STAFFORD LOGISTICS CENTER - TRAILER PARK

SITE PLAN

**STAFFORD LOGISTICS CENTER
TRAILER PARK
SITE PLAN
OVERALL SITE PLAN**
AURORA, CO

SHEET
C1.0
1

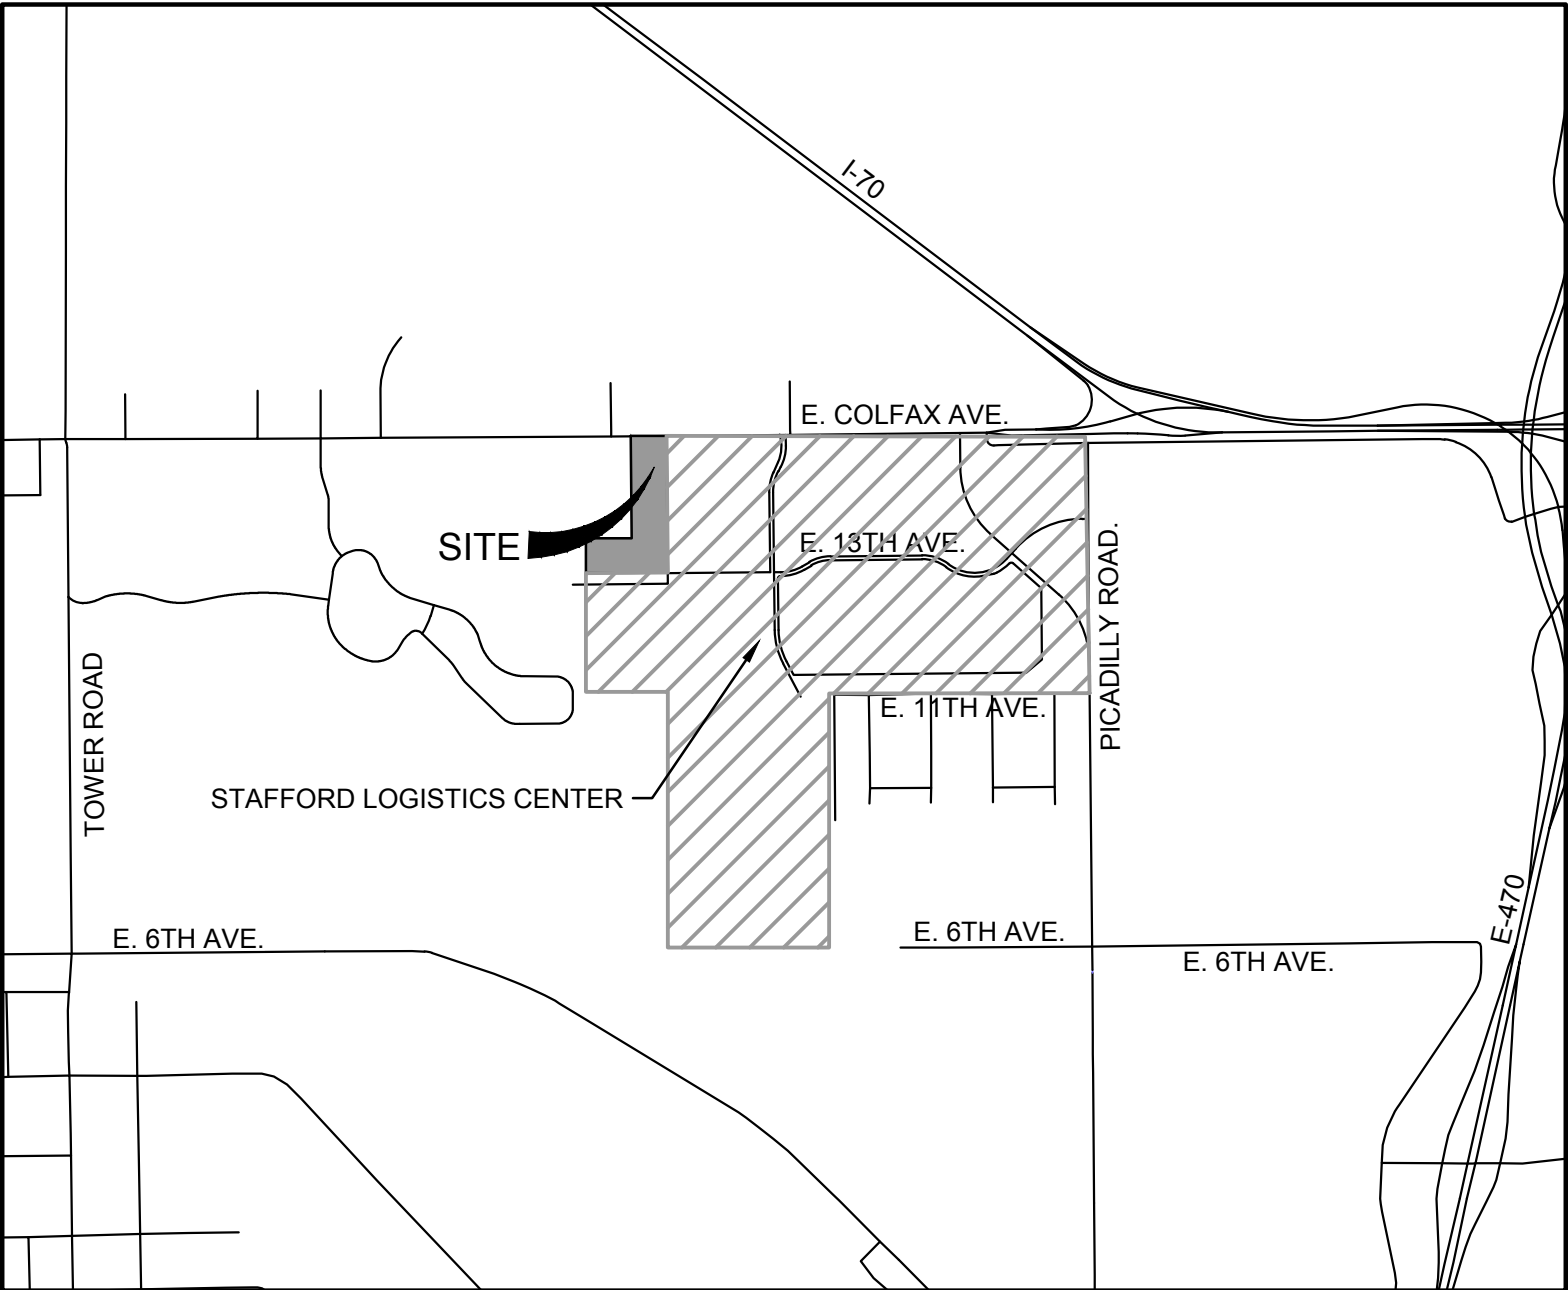
The site plan will not be approved by Aurora Water until the preliminary drainage report is approved.

At this time, the drainage report is in for signature set and under review of the drainage engineer.

Acknowledged

SHEET
C2.1
3

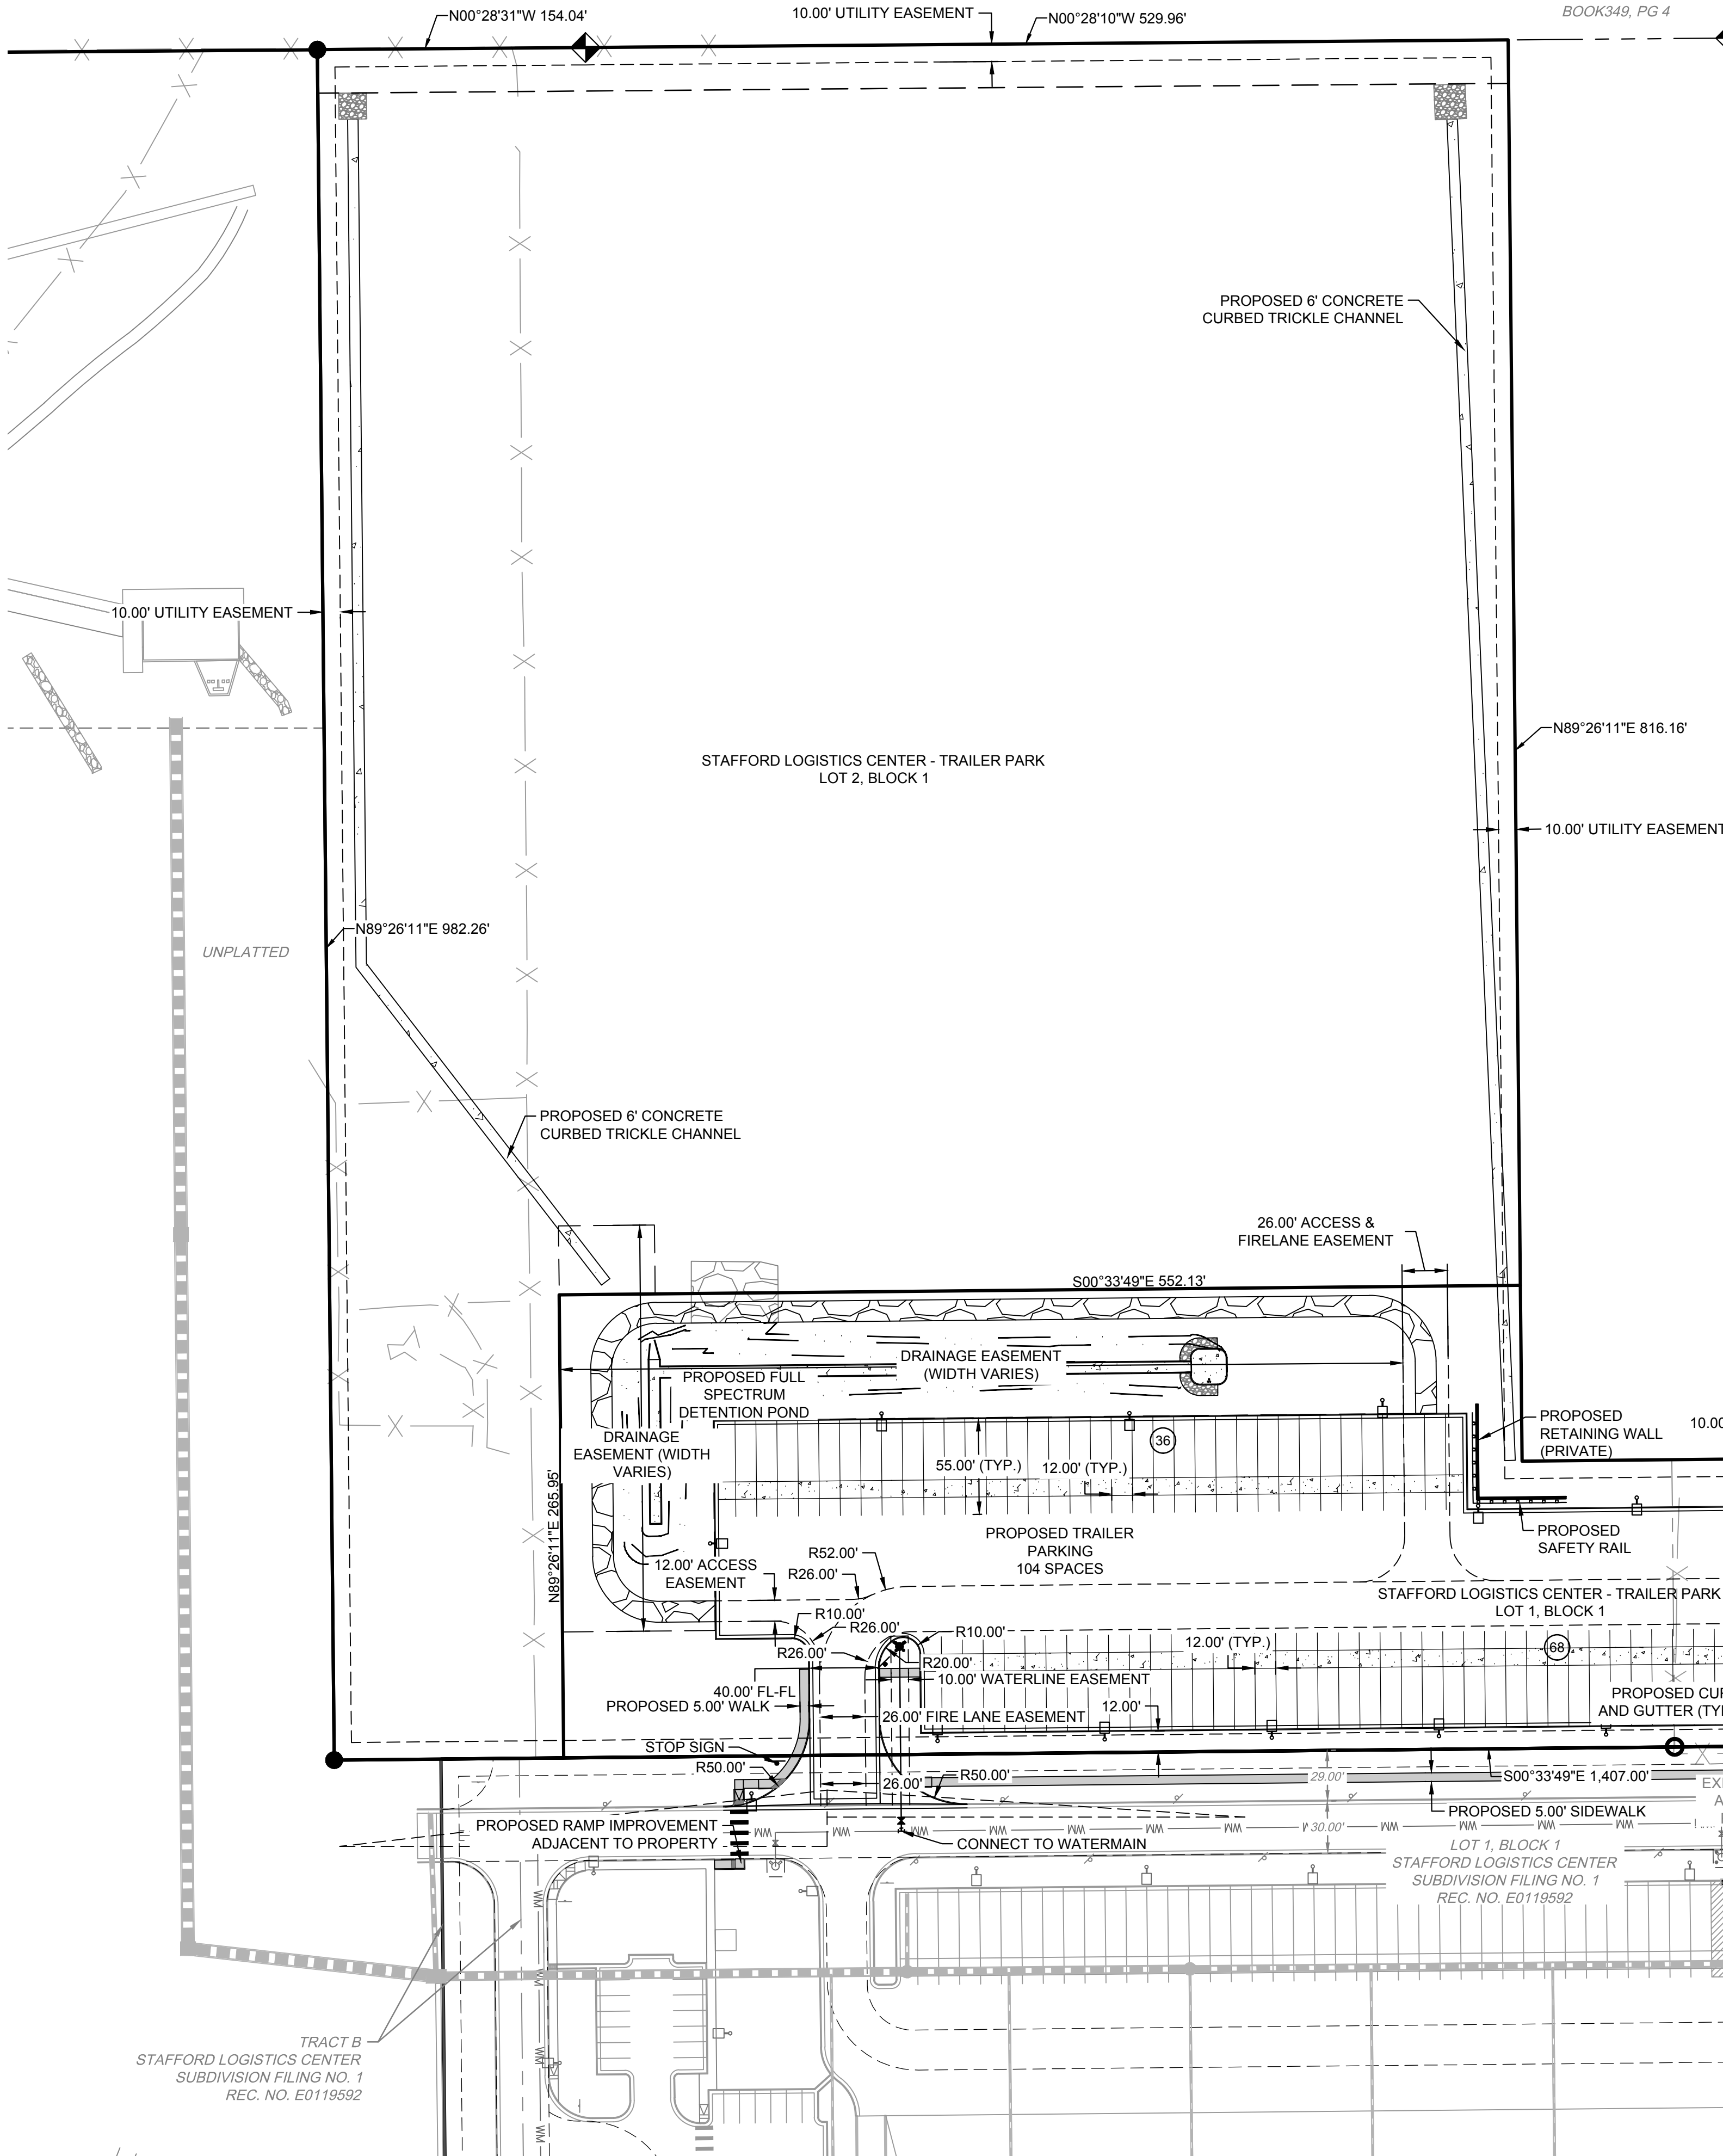
This is inaccurate. The sports park is zoned POS Parks and Open Space District. Please correct the note and label the zoning.

Zoning has been updated per comment

SHEET
C2.2

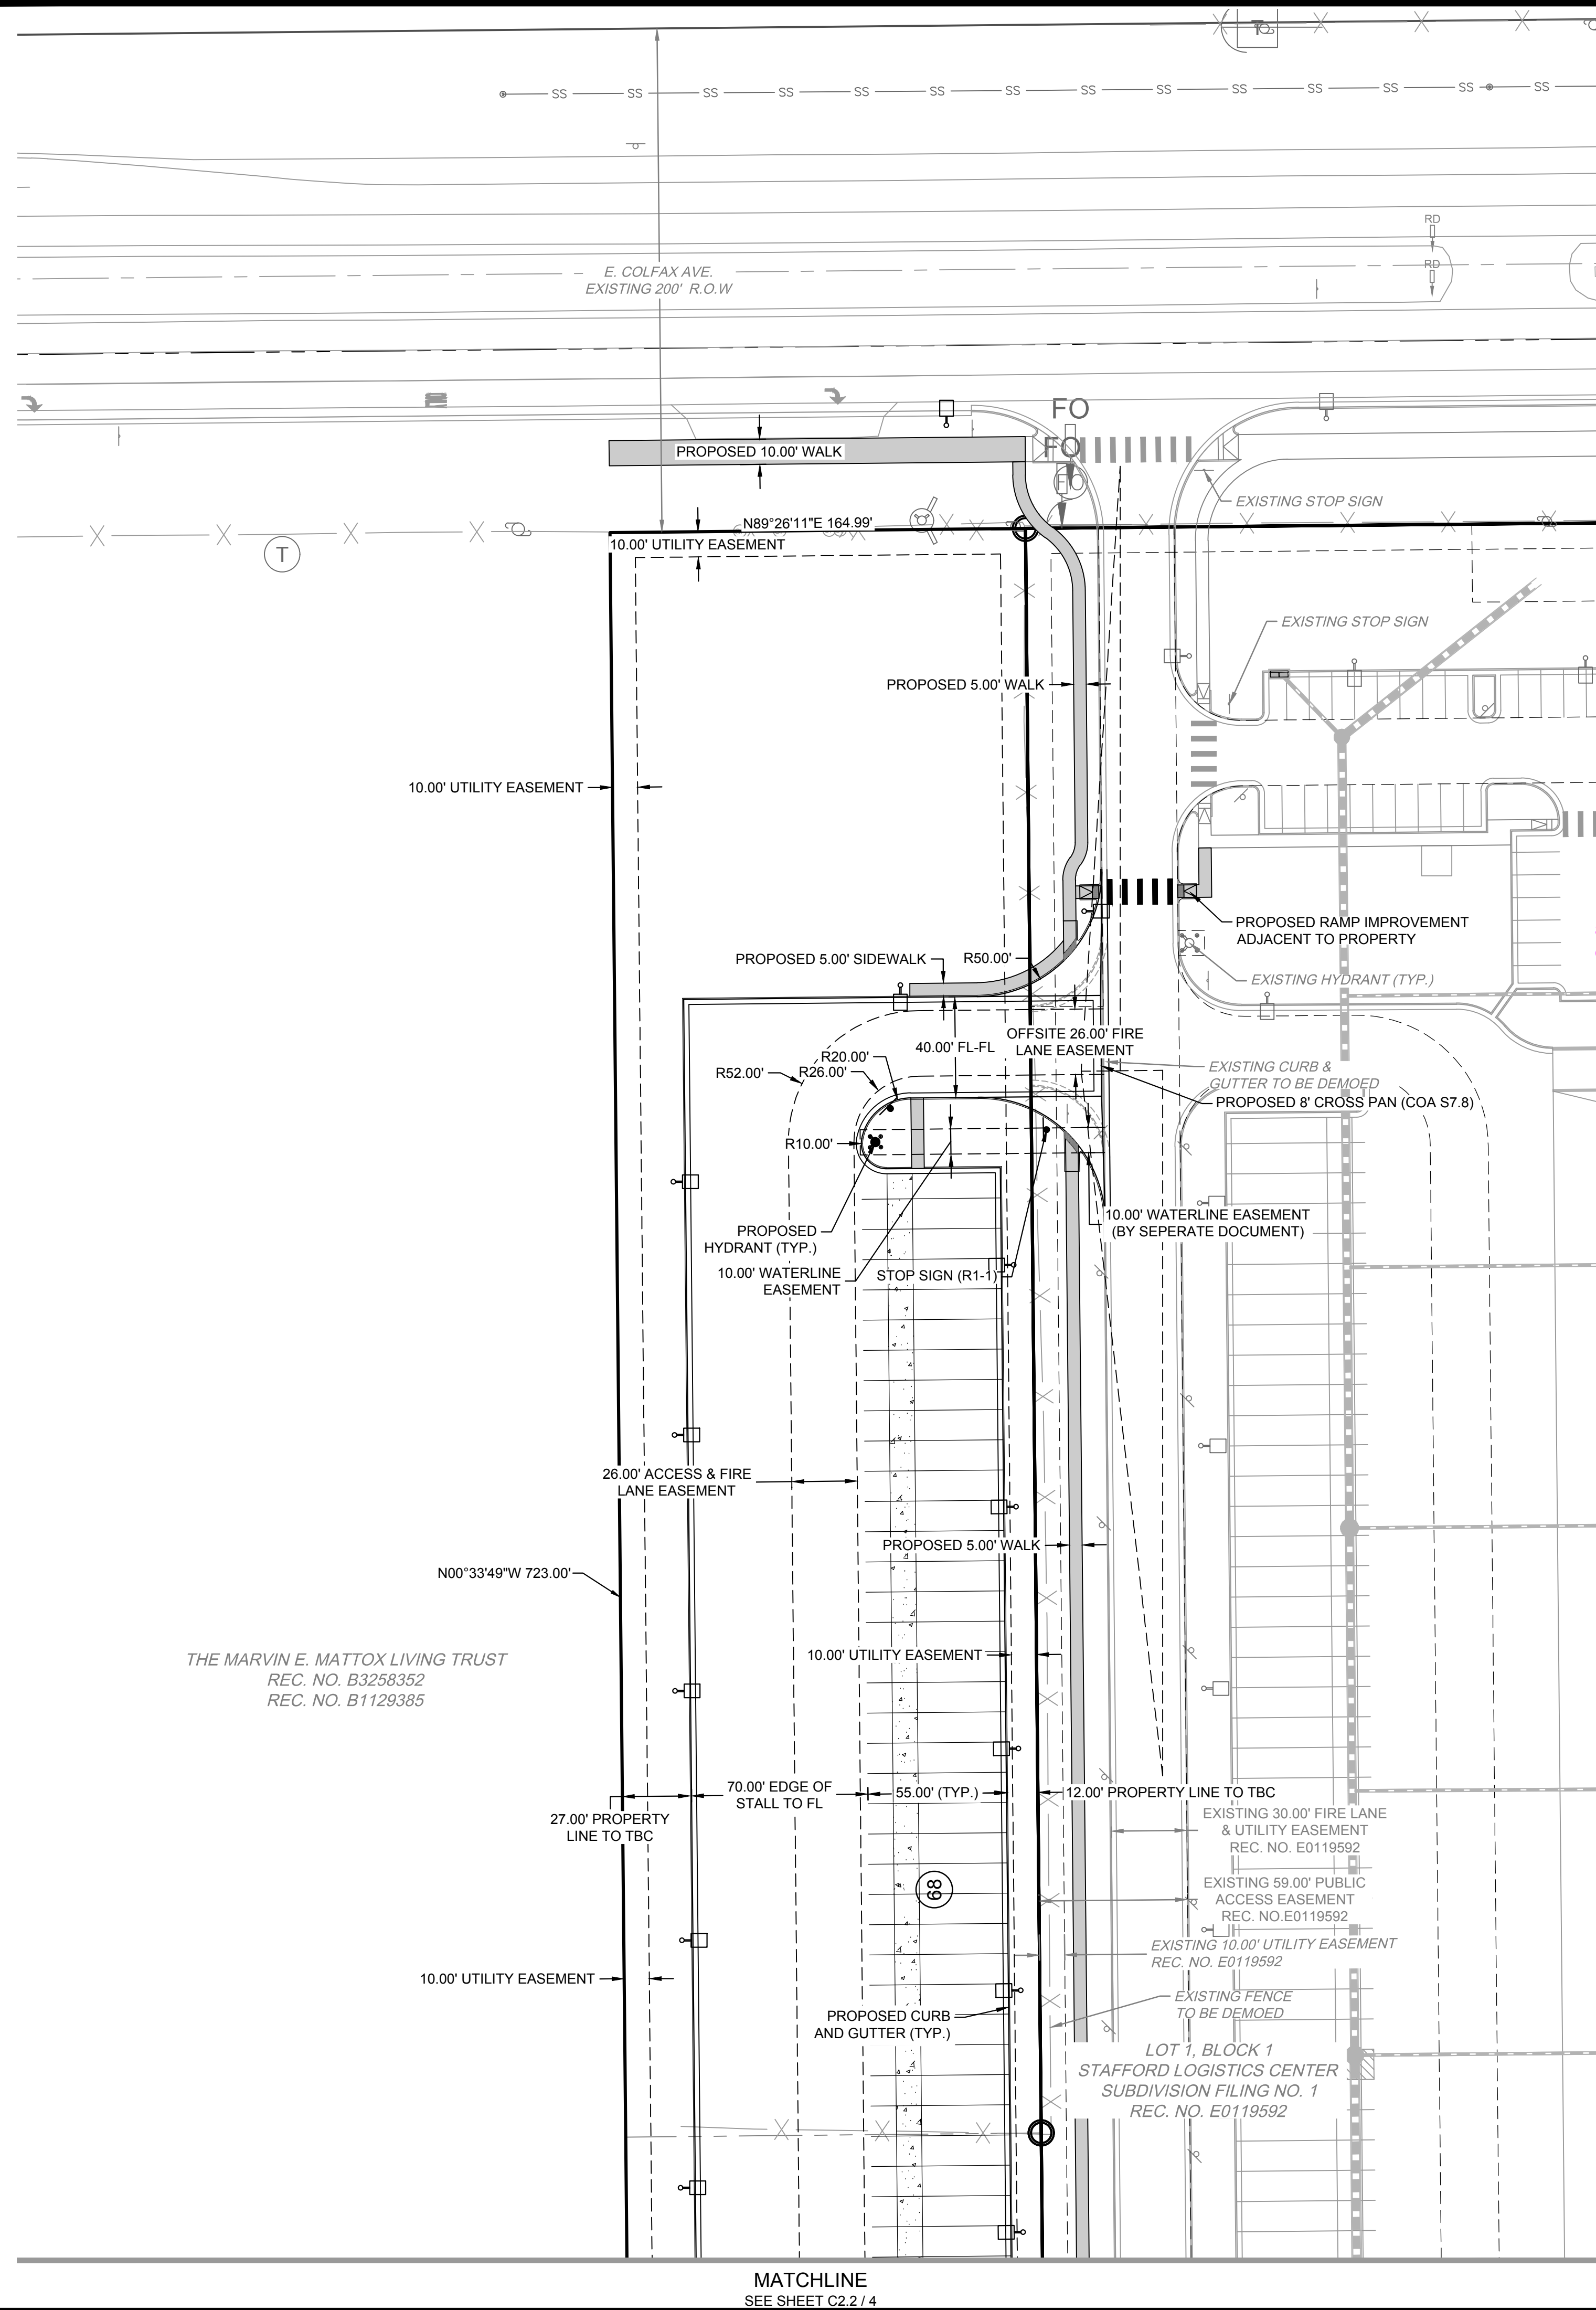
any off-site easements need to be dedicated by separate document
